TRANS/WP.29/2002/72
28 August 2002

PROPOSAL FOR DRAFT SUPPLEMENT 2 TO THE 01 SERIES
OF AMENDMENTS TO REGULATION No. 67

(Equipment for liquefied petroleum gas)

Transmitted by the Working Party on Pollution and Energy (GRPE)

Figure 1 - description of the impact test procedure:

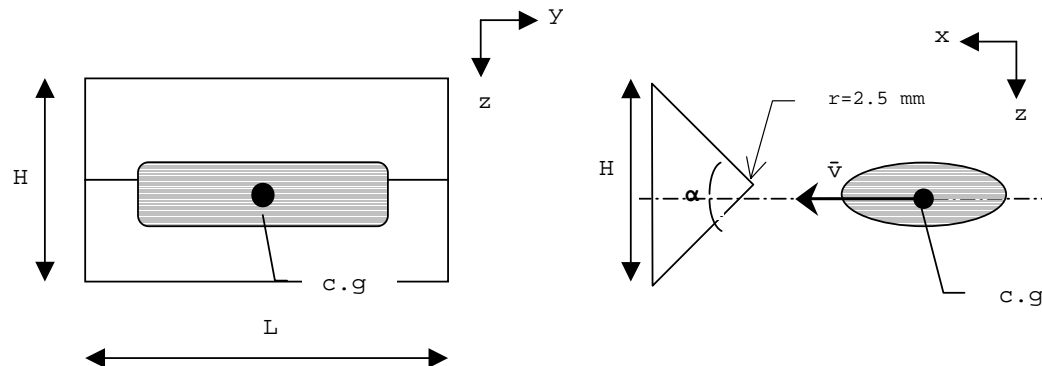
Insert paragraphs 2.7. to 2.11.3., to read:

"2.7. **Impact test**

A container filled with the fluid medium to the weight that equals the filling with 80 per cent of LPG with a reference mass of 0.568 kg/l, is projected, parallel to the length axle (x-axis in Figure 1) of the vehicle in which it is intended to be fitted at a velocity, V of 50 km/h, against a solid wedge, fixed horizontally, perpendicular to the movement of the container.

The wedge shall be installed so that the centre of gravity (c.g.) of the container hits the centre of the wedge.

The wedge shall have an angle α of 90 degrees and the point of impact shall be rounded with a maximum radius of 2.5 mm. The length of the wedge L , shall be at least equal to the width of the container in respect to its movement during the test. The height H of the wedge shall be at least 600 millimetres
